Consumer Product SAFETY ALERT

Consumers Urged to Replace Horn On Century Roadster Walker

Replacement Horns Available On Century Roadster Walkers Because Of Choking Hazard

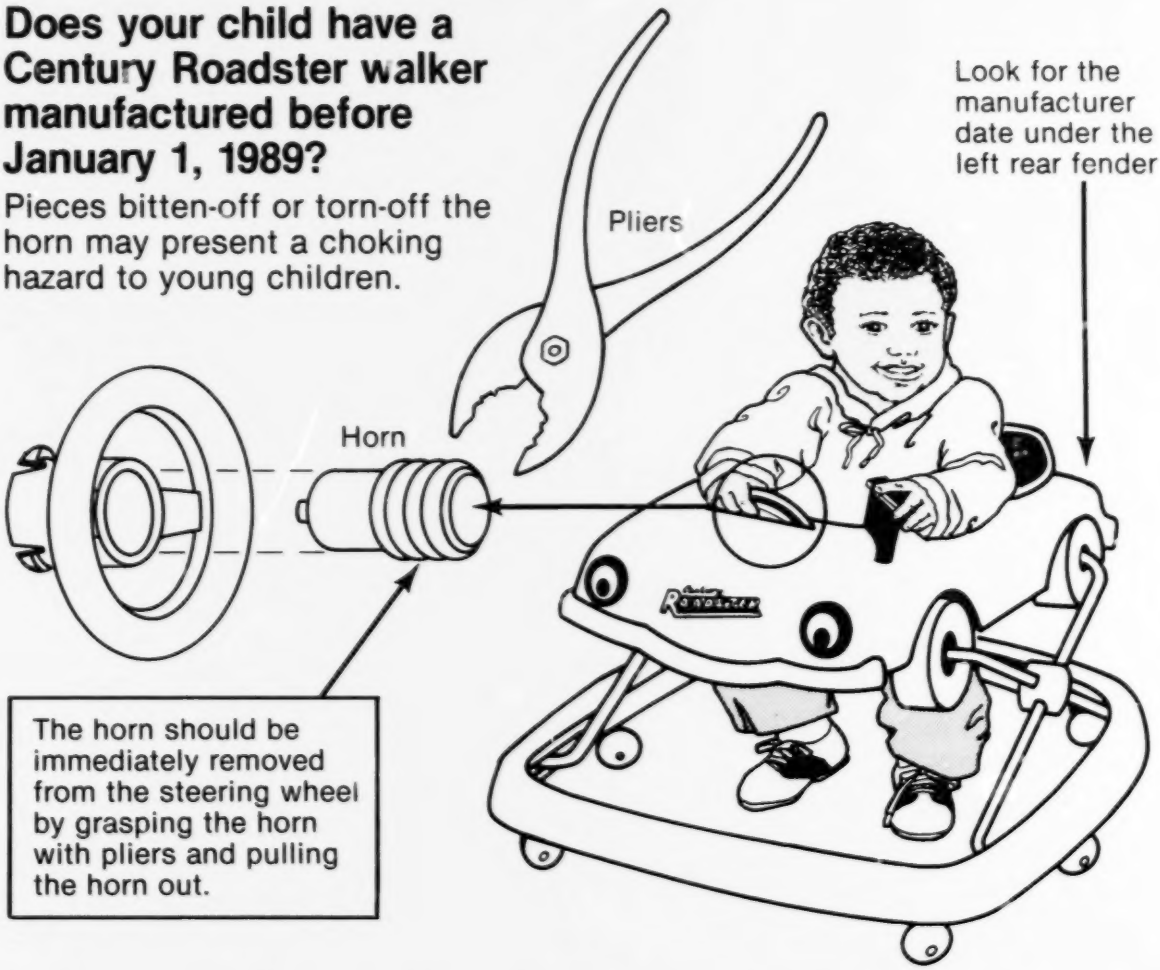
Pieces bitten-off or torn-off the horn may present a choking hazard to young children.

Look for the manufacturer date under the left rear fender
Pliers
Horn
The horn should be immediately removed from the steering wheel by grasping the horn with pliers and pulling the horn out.

The top of the redesigned horn will be larger and made of a strong, thick plastic material. (Horns on walkers manufactured after January 1, 1989 are not affected by this replacement.
